STONE AND WEBSTER MICHIGAN, INC.  
P.O. BOX 1963, MIDLAND, MICHIGAN 48640

<b>STONE &amp; WEBSTER</b> <b>CONSTRUCTION IMPLEMENTATION</b> <b>OVERVIEW</b> <b>MIDLAND NUCLEAR PLANT J.O. NO. 14509</b>	ITEM NUMBER <div style="text-align: center; font-size: 1.2em;">072</div>	HOLD POINT NUMBER 
REFERENCE(S) ANSI N45.2 Section 7	<input type="checkbox"/> TRACKED ACTION ITEM <input checked="" type="checkbox"/> TRACKED INFORMATION ITEM <input type="checkbox"/> TRACKED RECOMMENDATION ITEM <input type="checkbox"/> UNTRACKED ITEM <input type="checkbox"/> HOLD POINT NOTIFICATION

Midland Plant Units 1 & 2  
Bechtel Job 7220  
STONE & WEBSTER OVERVIEW  
ITEM NO. 072  
BCCC-9287

Midland Project Units 1 & 2  
Bechtel Job 7220  
STONE & WEBSTER OVERVIEW  
ITEM NO. 073  
BCCC-9288

NDE-PQ-RT-200

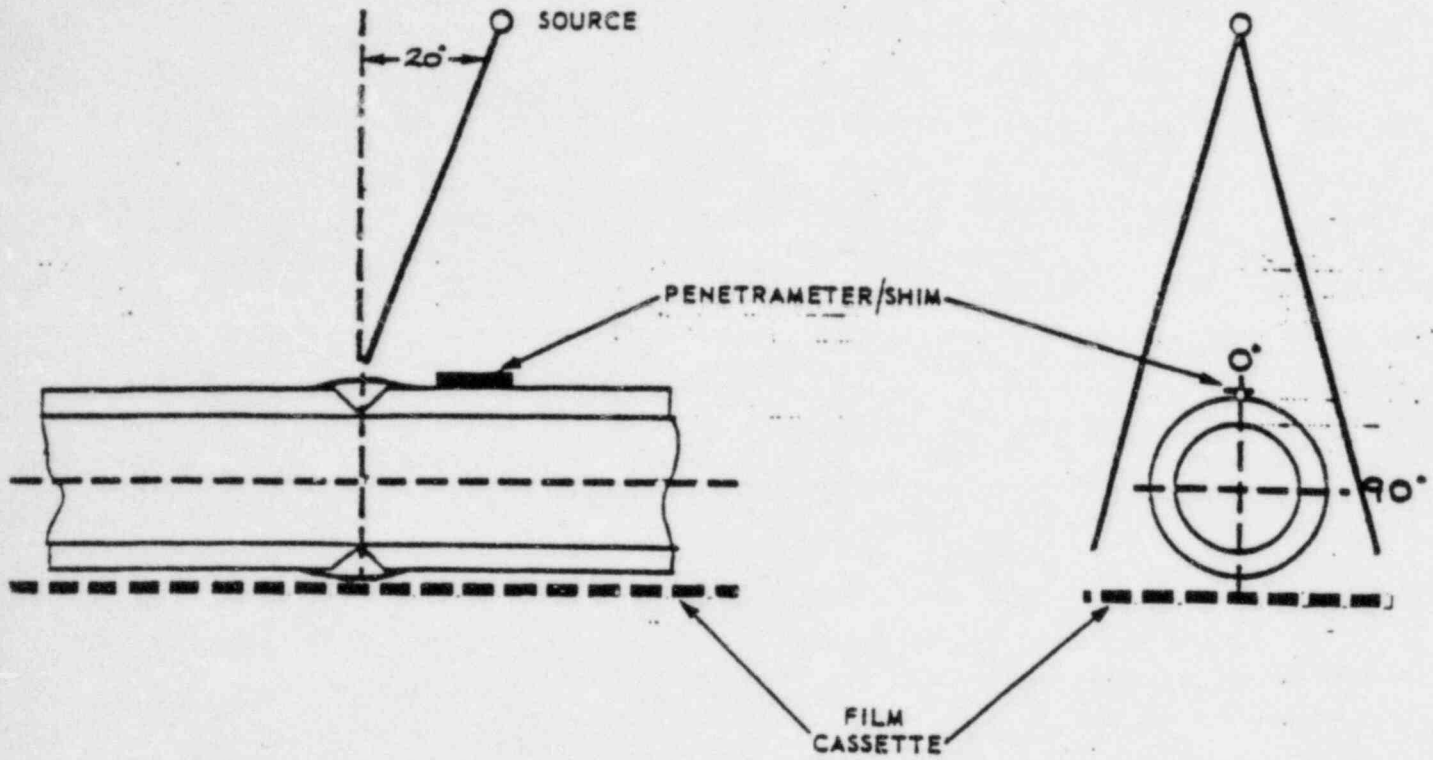
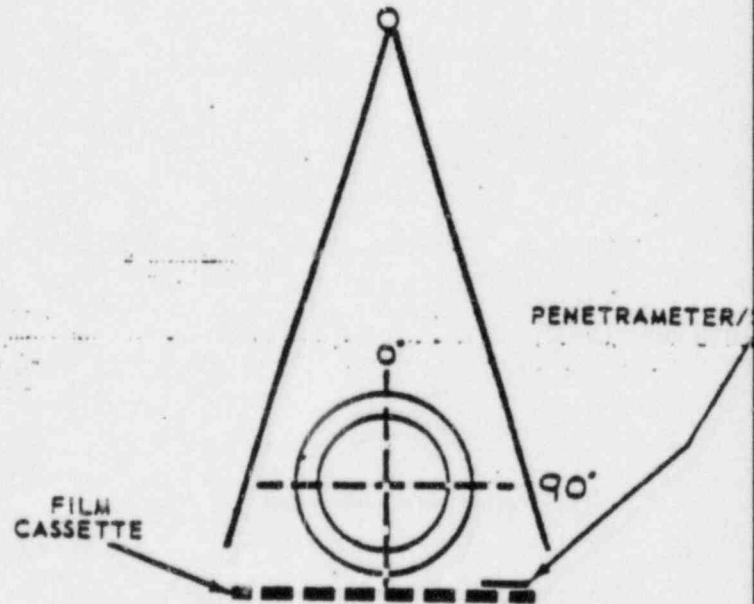
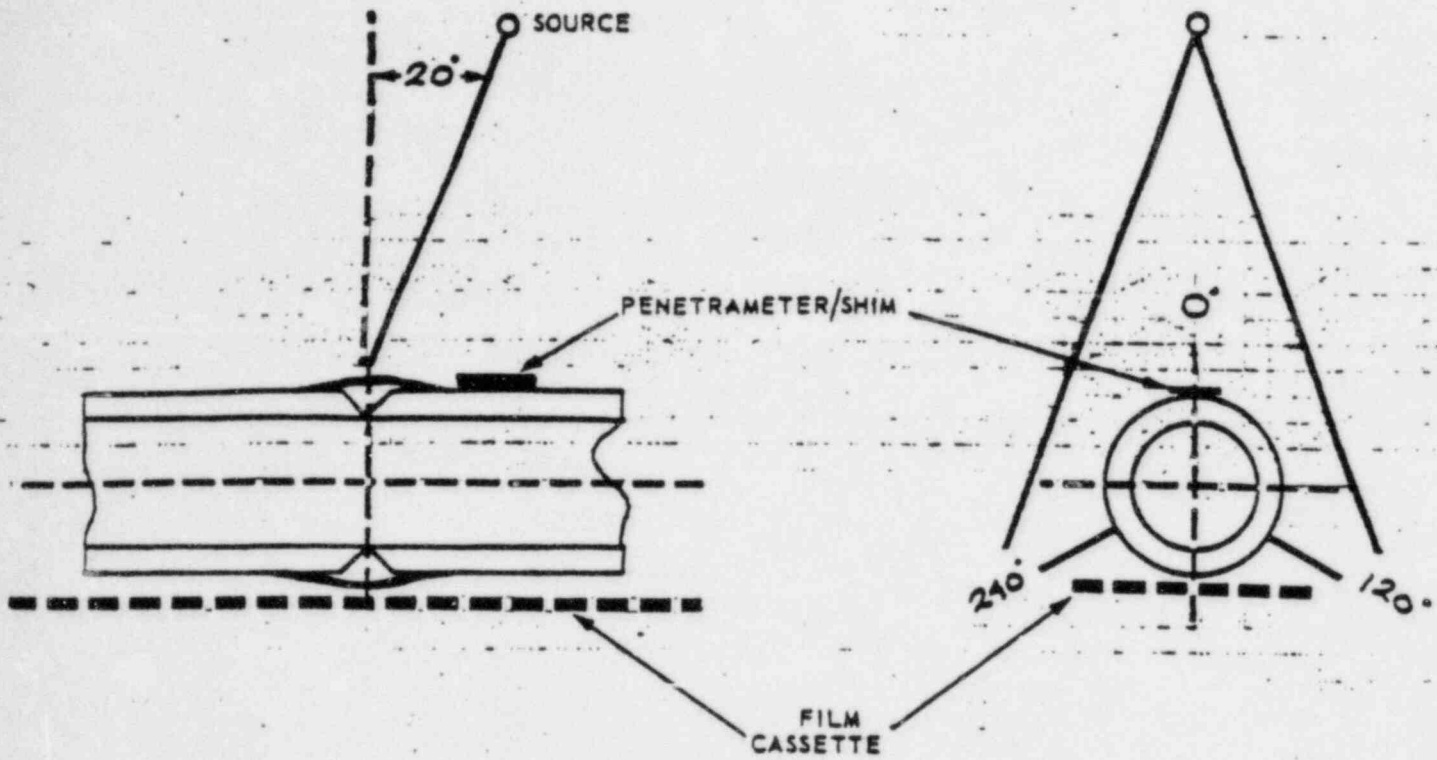
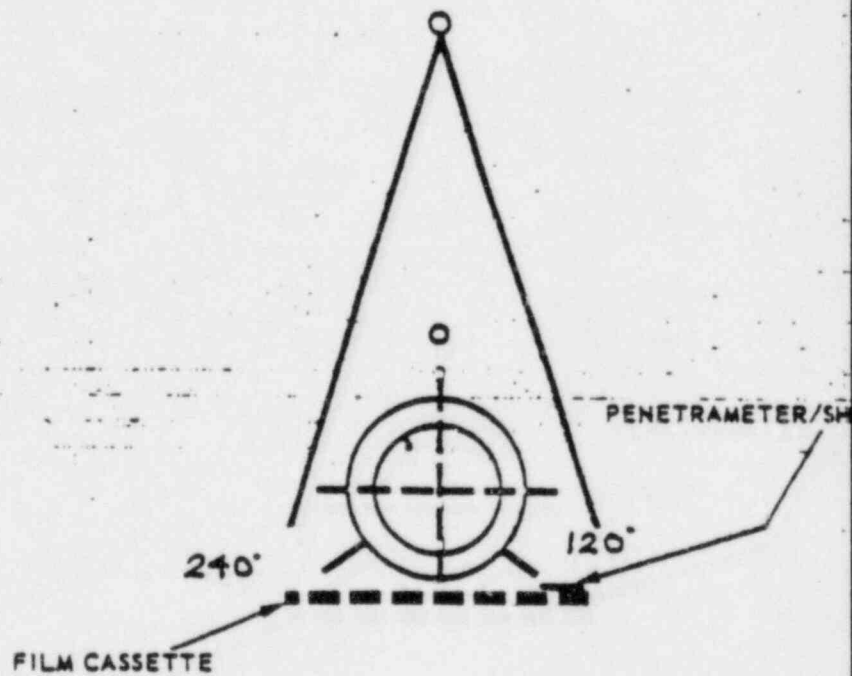
- A) Procedure NDE-PQ-RT - 200  $\Delta$  consist of 3 pages  
 Page 1 of 3 reads: NDE-PQ-RT-200 Page 1 of 3 Revision 1  
 Page 2 of 3 reads: 9T-RT-200 Page 2 of 3 No Revision specified  
 Page 3 of 3 reads: 9T-RT-200 Page 3 of 3 No Revision specified
- B) Procedure NDE-PQ-RT-201  $\Delta$  consist of 3 pages  
 Pages 2 of 3 and 3 of 3 lack procedure number and revision.
- C) Procedure NDE-PQ-RT-202  $\Delta$  consist of two pages  
 Pages 1 & 2 lack page number

- A) NDE-PQ-RT-200, Rev 1, Page 2 of 3 & Page 3 of 3 have been annotated with NDE-PQ-RT-200, Rev 1.
- B) NDE-PQ-RT-201, Rev 1, Page 2 of 3 & Page 3 of 3 have been annotated with NDE-PQ-RT-201, Rev 1.
- C) NDE-PQ-RT-202, Rev 0, Pages 1 & 2 have been numbered.

Procedure NDE-PQ-RT-200 Revision 1, Page 2 of 3 and Page 3 of 3, have been annotated with PQ-RT-200 Revision 1.
